6.1	<p>Drawings: E3-1 E3-2</p> <p>Specifications: PTSS Conduit & Cabling Specifications as of 2015-06-03</p>
-----	--

End of Addendum No.2.

project title / titre du projet
RCMP ESTEVAN TENANT FIT-UP
 1320 4TH STREET ESTEVAN, SASKATCHEWAN
 drawing title / titre du dessin
MAIN FLOOR ELECTRICAL PTSS

1
 PTSS-MAIN FLOOR
 1/4"=1'-0"

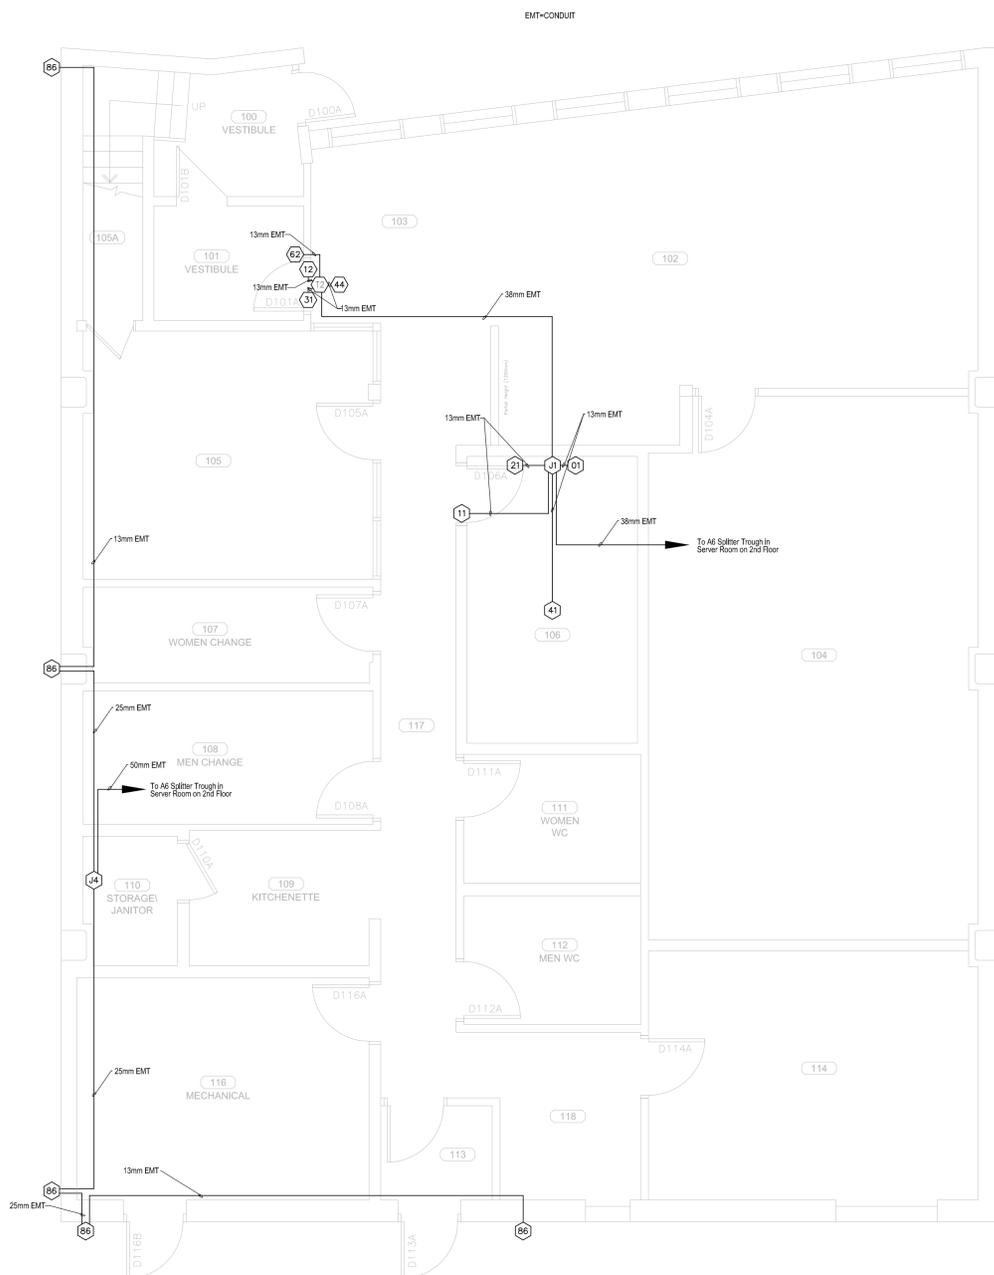
5.1.	<p><u>Reference: E3-1 First Floor Electrical PTSS</u></p> <ol style="list-style-type: none">1. Rough-in installation of intrusion alarm (PTSS) system on first floor to be as per drawing E3-1 and attached RCMP provided installation specifications ("PTSS Conduit & Cabling Specifications as of 2015-06-03").2. Refer to additional drawing E3-1.3. Refer to additional specification PTSS Conduit & Cabling Specifications as of 2015-06-03.
5.2.	<p><u>Reference: E3-2 Second Floor Electrical PTSS</u></p> <ol style="list-style-type: none">1. Rough-in installation of intrusion alarm (PTSS) system on second floor to be as per drawing E3-2 and attached RCMP provided installation specifications ("PTSS Conduit & Cabling Specifications as of 2015-06-03").2. Refer to additional drawing E3-2.3. Refer to additional specification PTSS Conduit & Cabling Specifications as of 2015-06-03.

2
 DOOR D101A DETAIL
 NTS

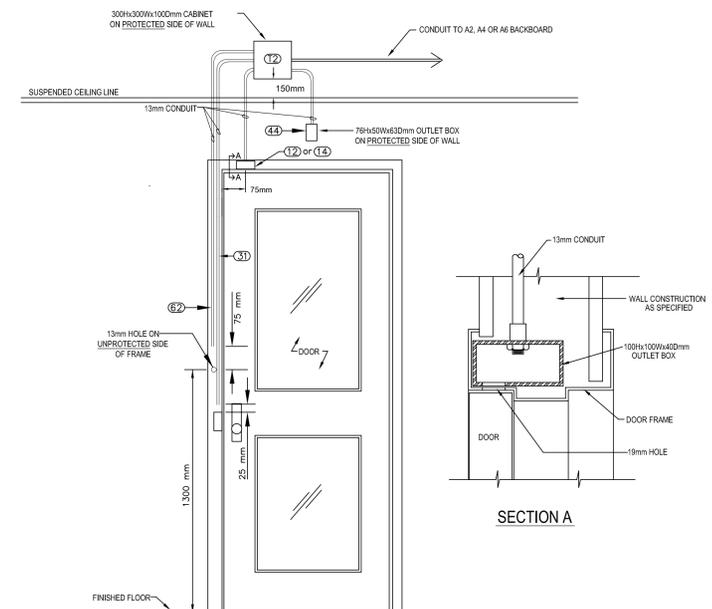
4.1.	
4.2.	
4.3.	<u>Refer to Appendix 2 Hardware Schedule</u> Add following items to Hardware Group 2 (Door D101A): -SDS-55DU-630 electric strike -BPS24-1 power supply -card reader by others
